KSU-21S701 RFQ Pre-submittal Questions

**Office of the University Sign-In Sheet
KENT STATE UNIVERSITY
KSU-21S701 Trumbull Link Building Exterior Envelope Repair
SIGN-IN SHEET**

| DRAWING TITLE | | |
|-------------------------|------------|--|
| WALL SECTIONS / DETAILS | | |

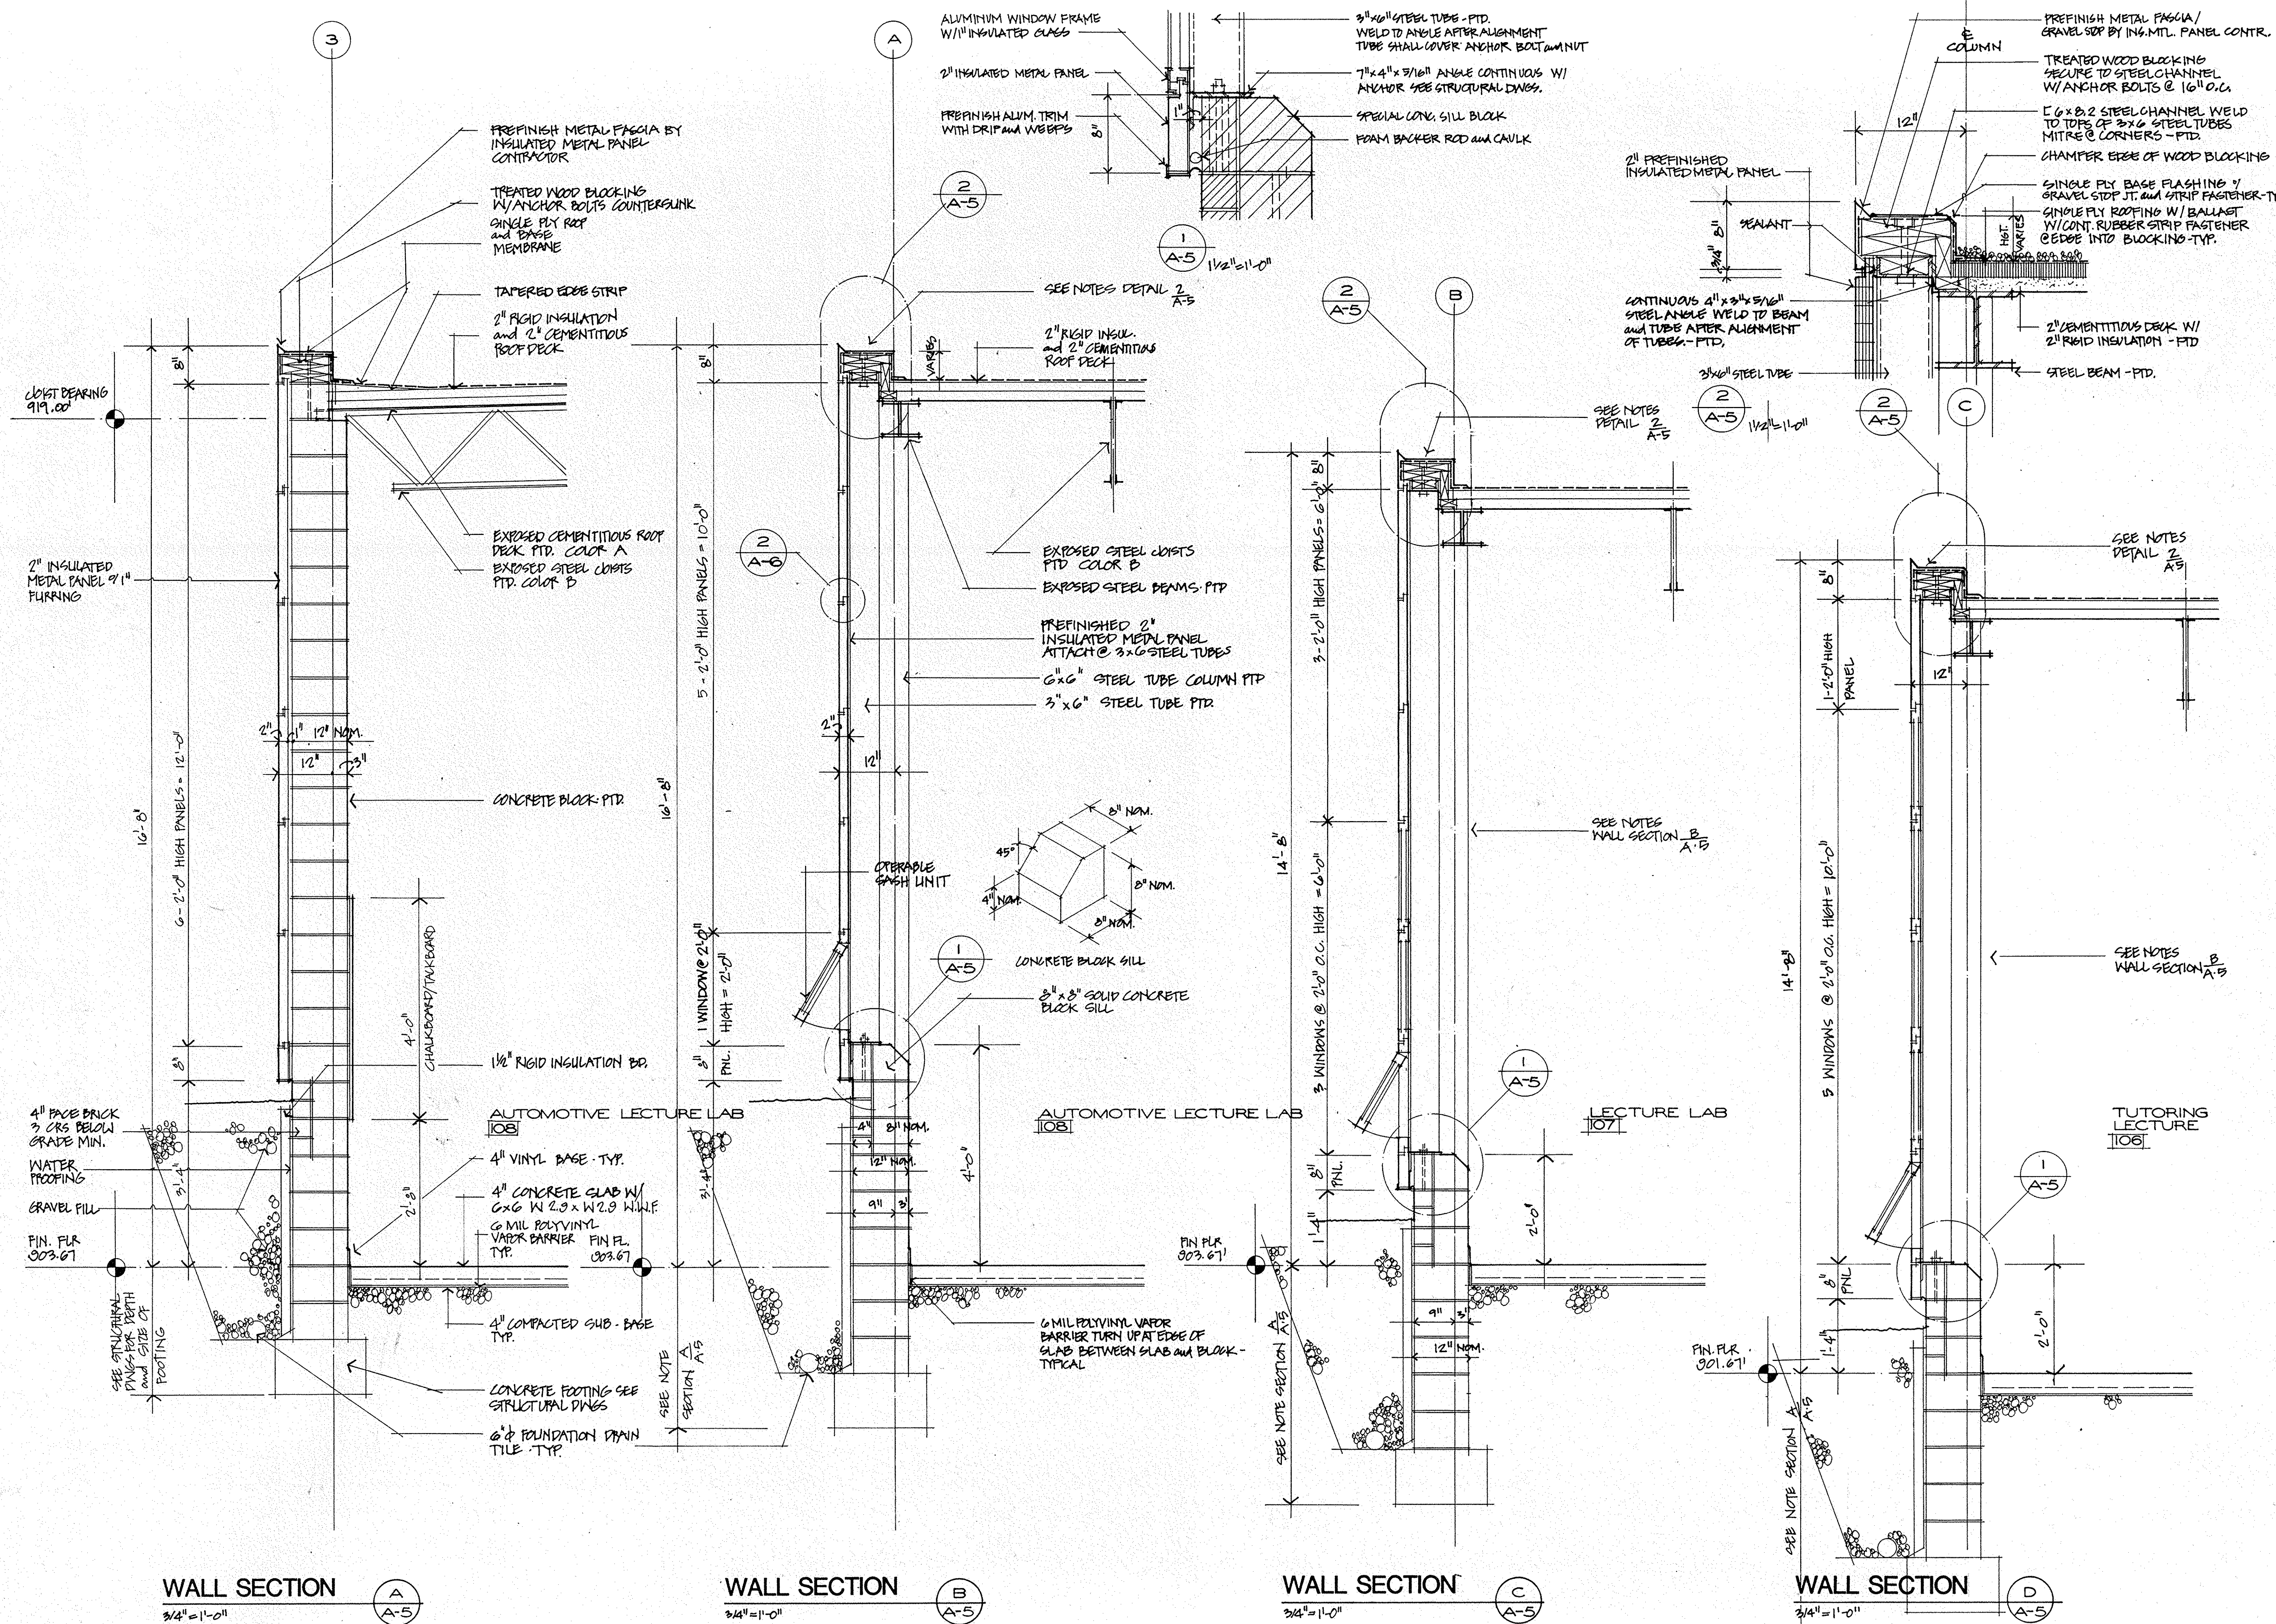
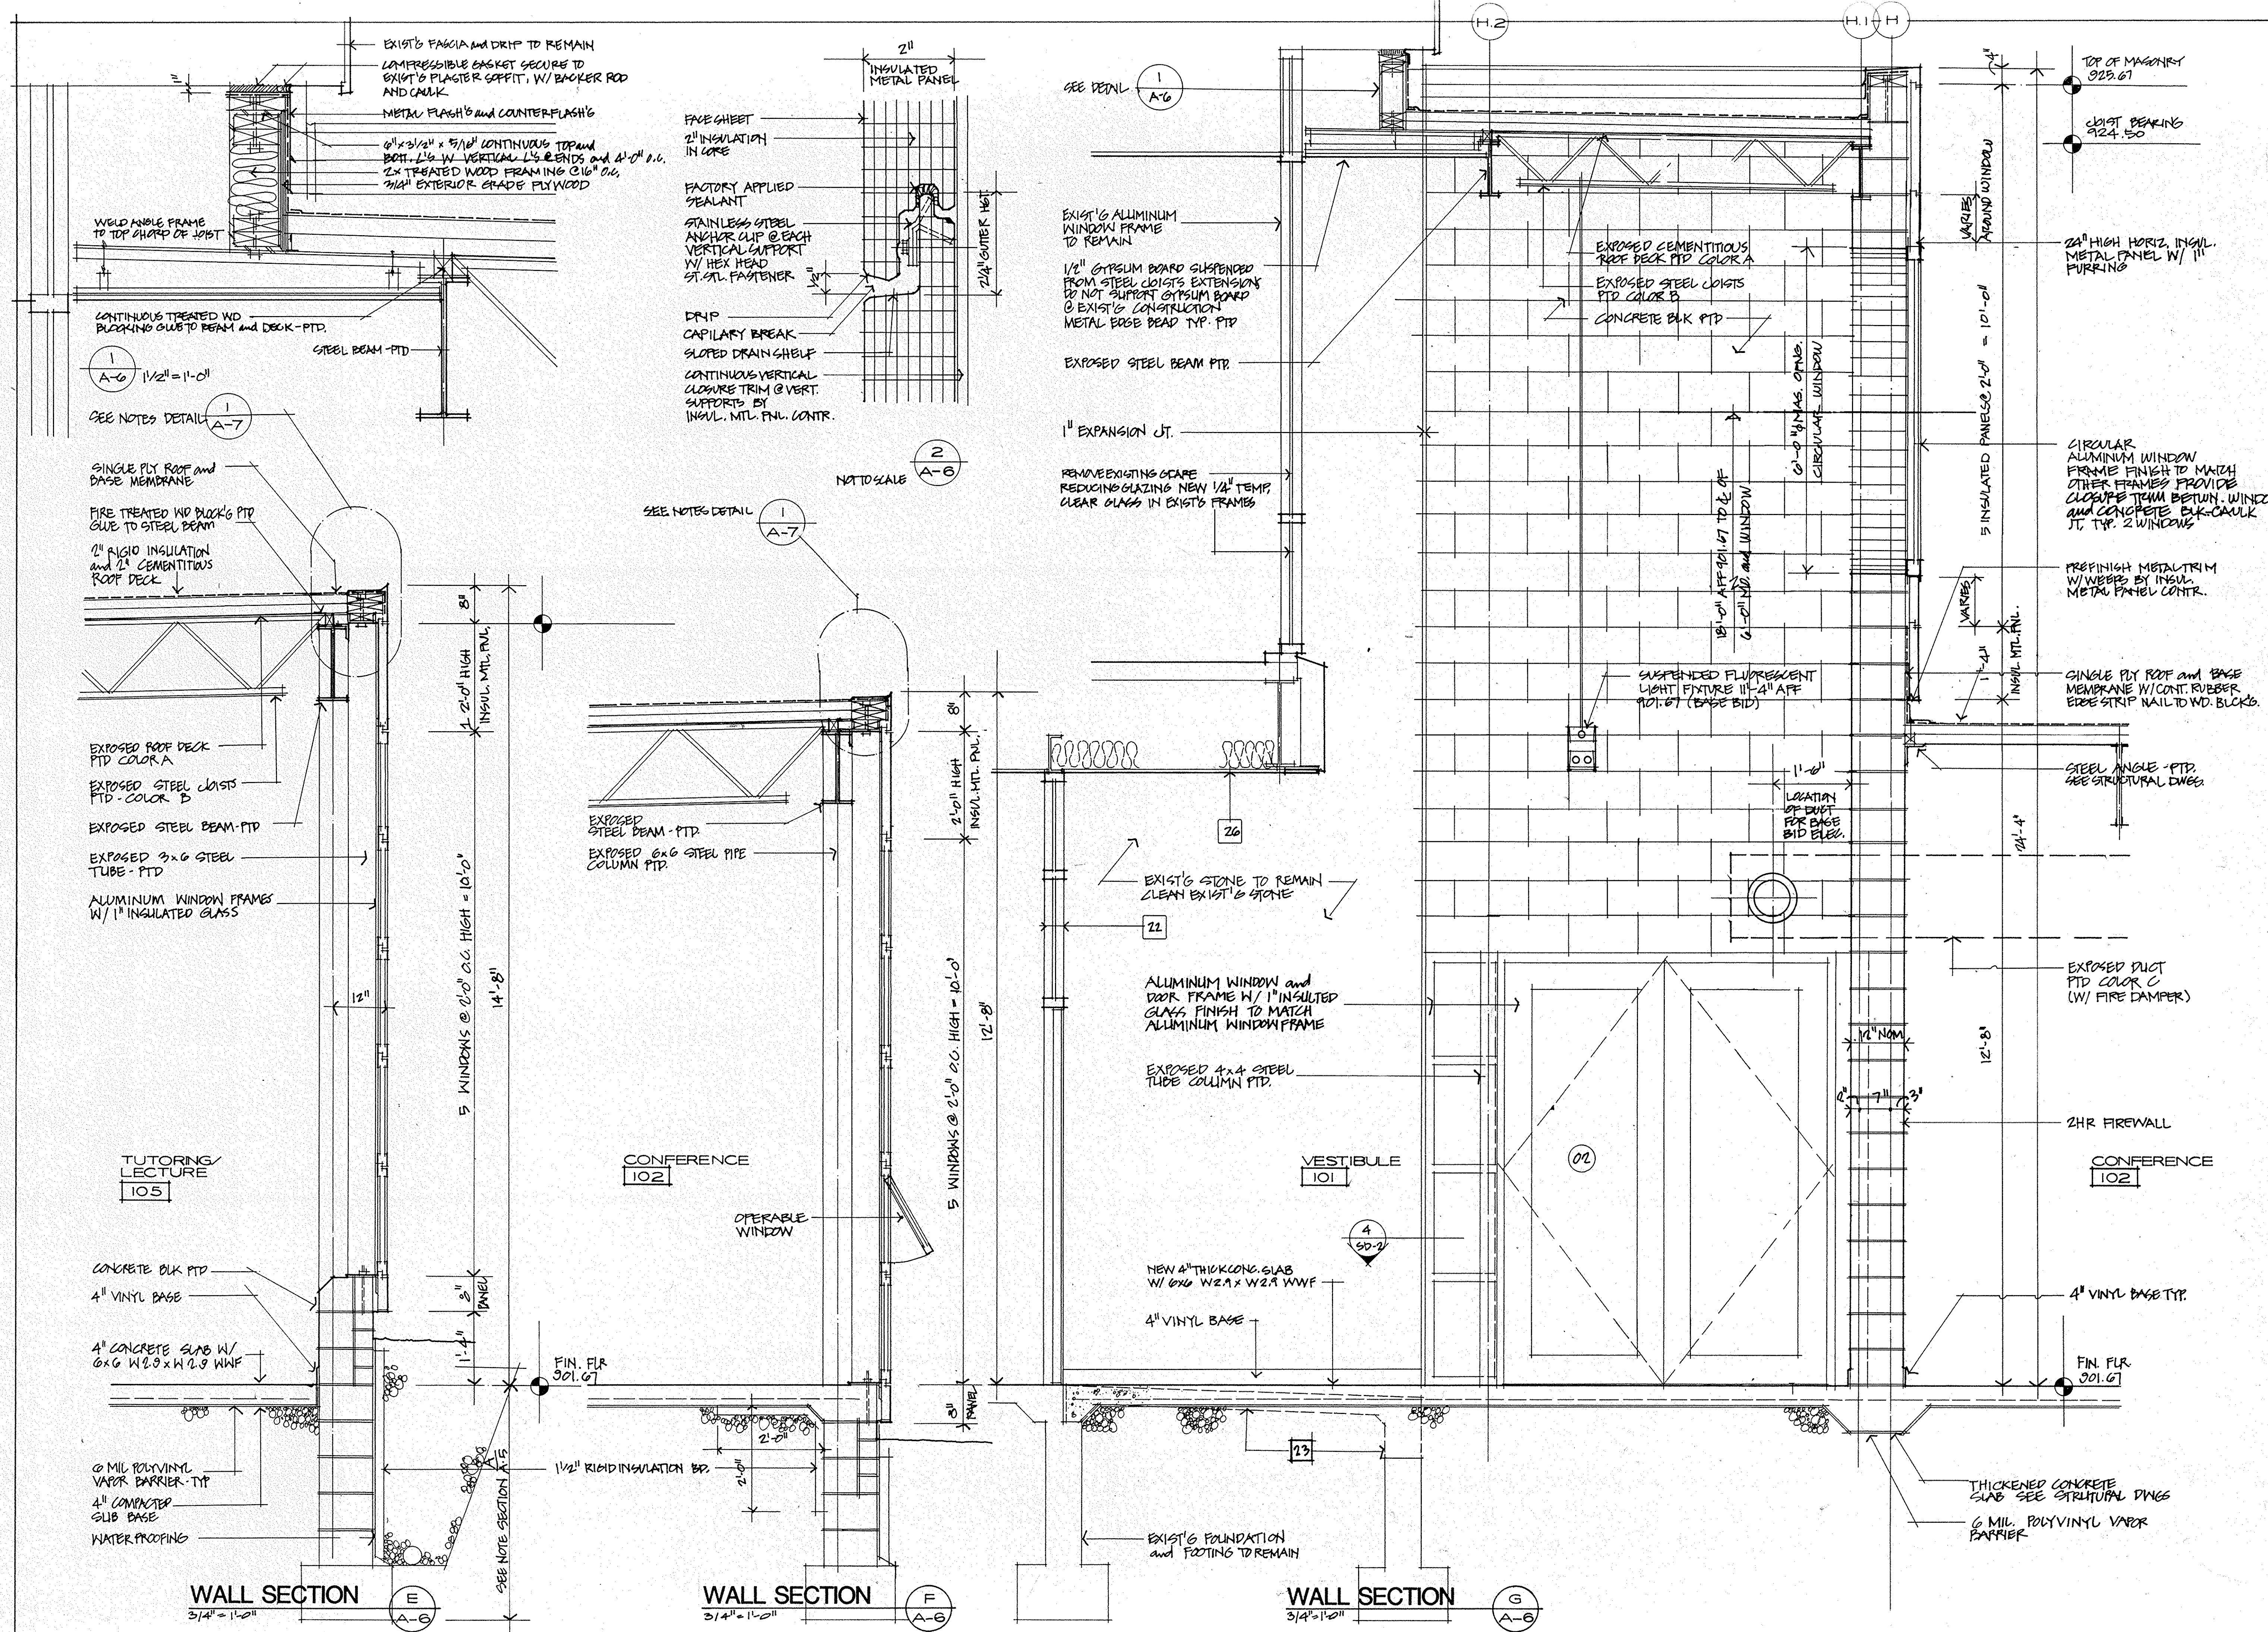
1. Please provide reference wall sections.
 - a. Attached
2. Please provide roofing information.
 - a. Link roofing info: Tremco Powerply Premium SMO installed 10/2009 with a 30year warranty. Advanced Industrial Roofing, Massillon Ohio.
 - b. Science and Technology Building roof: Firestone EPDM Fully Adhered; various contractors and install dates –all out of warranty
3. Sign-in Sheet attached
